Comment 84: 802.3aq LRM Draft 3.0

802.3aq LRM interim meeting

Summary Graphic – Comment 84

Differences in “statistics” of OM1/OM2/OM3

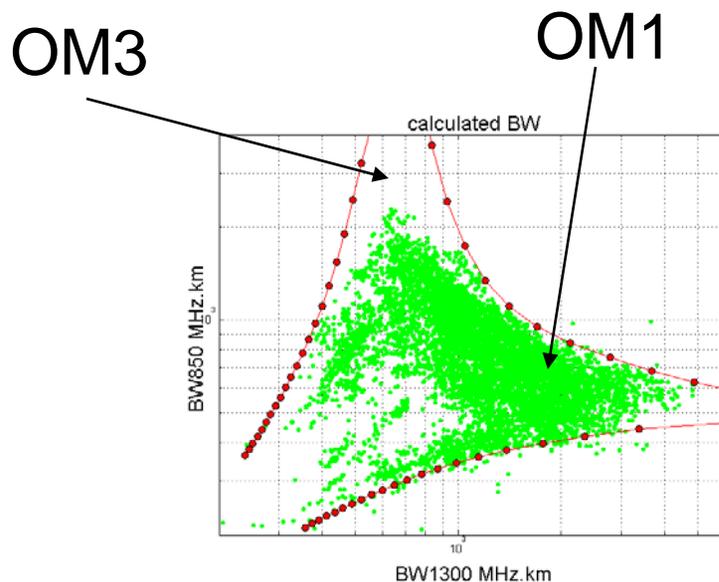
The OM1 distribution is optimized for 1300nm, the OM3 distribution is optimized for 850nm, and the OM2 “distribution” is less well defined, because customers have ordered 1300nm-optimized, 850nm-optimized, and dual window fiber.

European OM2 orders proportionally more 500/1200=1300nm optimized;

US OM2 orders mixed, proportionally more 500/500. If perfectly balanced, OFL850 & OFL1300 match.

OM2: OFL BW850 vs OFL BW1300

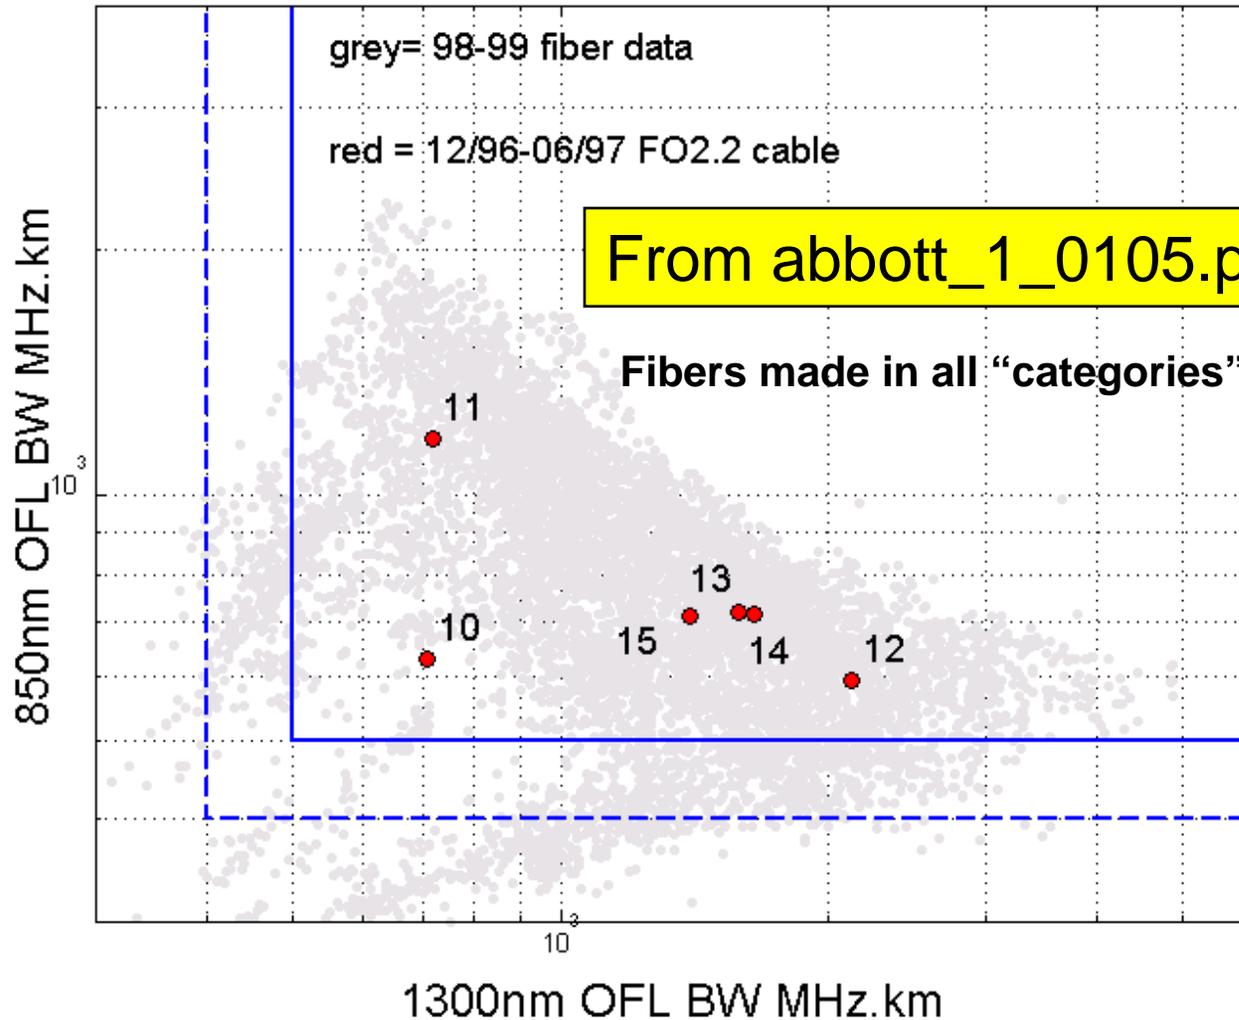
The OM2 analysis should be modified to be closer to worst case. An individual installation will likely have 'similar' fibers so that it makes sense to design for sub-populations of the OM2 distribution, and guarantee performance for the subpopulations.
